Dealer4

Firmware Updates Information 17.05.2017

Version 3.06 – published 12.02.2014

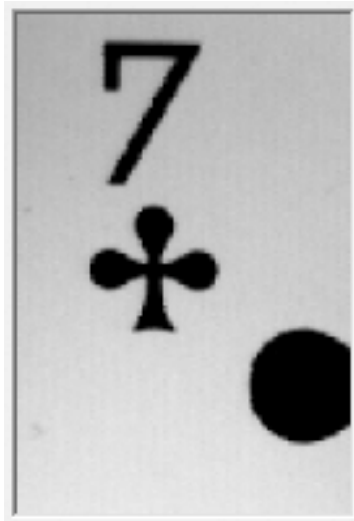
- increased dealing speed (to average 5.4-5.5s)
- improved reading Danish cards
- added special option to recognize cards where the 7 has an elongated top left section as shown below. This option can be enabled by setting **Recognize Option** to 16 in the **Maintenance** screen.

Version 2.78 – published 12.07.2012

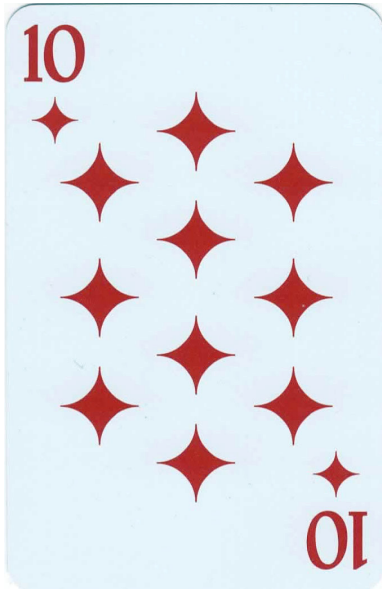
- Corrected a problem with club recognition for Japan Nintendo Cards:

Version 2.58 – published 16.06.2011

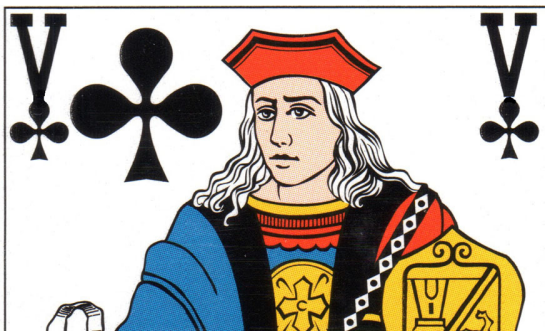
- Improved automatic camera adjustment to make it less sensitive to external light
- Improved recognition of cards with outside frame
- Added recognition of French Bridge Diffusion cards with symbol touching or too close to the suit:

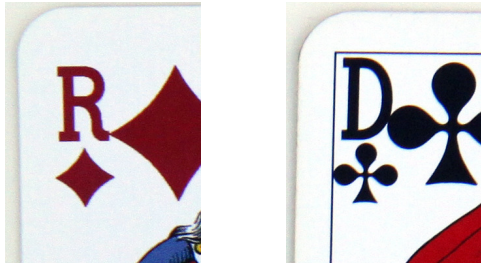
- Corrected recognize cards when something is touching the symbol on the right side:

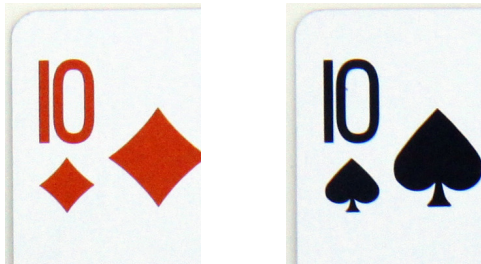
- Added recognition of 10 with very close 1 to 0:
